Title of Change:	NCS2632DTBR2G design change to reduce power on reset (POReset) level.
Proposed First Ship date:	06 Mar 2020 or earlier if approved by customer
Contact Information:	Contact your local ON Semiconductor Sales Office or <Jeremy.Becker@onsemi.com>
PCN Samples Contact:	Contact your local ON Semiconductor Sales Office or <PCN.samples@onsemi.com>. Sample requests are to be submitted no later than 30 days from the date of first notification, Initial PCN or Final PCN, for this change. Samples delivery timing will be subject to request date, sample quantity and special customer packing/label requirements.
Additional Reliability Data:	Contact your local ON Semiconductor Sales Office or <Vladislav.Hrachovec@onsemi.com>
Type of Notification:	This is a Final Product/Process Change Notification (FPCN) sent to customers. FPCNs are issued 90 days prior to implementation of the change. ON Semiconductor will consider this change accepted, unless an inquiry is made in writing within 30 days of delivery of this notice. To do so, contact PCN.Support@onsemi.com

QV DEVICE NAME : NCS2632DTBR2G

Electrical Characteristics Summary:**POR Reset Before change:**

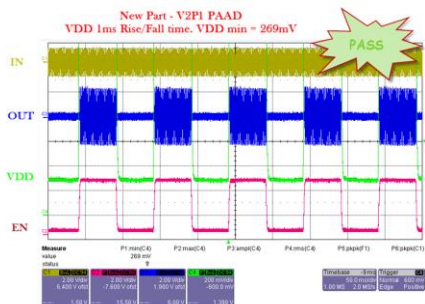
Old Part. Using Function Generator for Pulsing Unit On/OFF

VDD = 0.269 to 5V - 1ms R/F time – Unit Fails
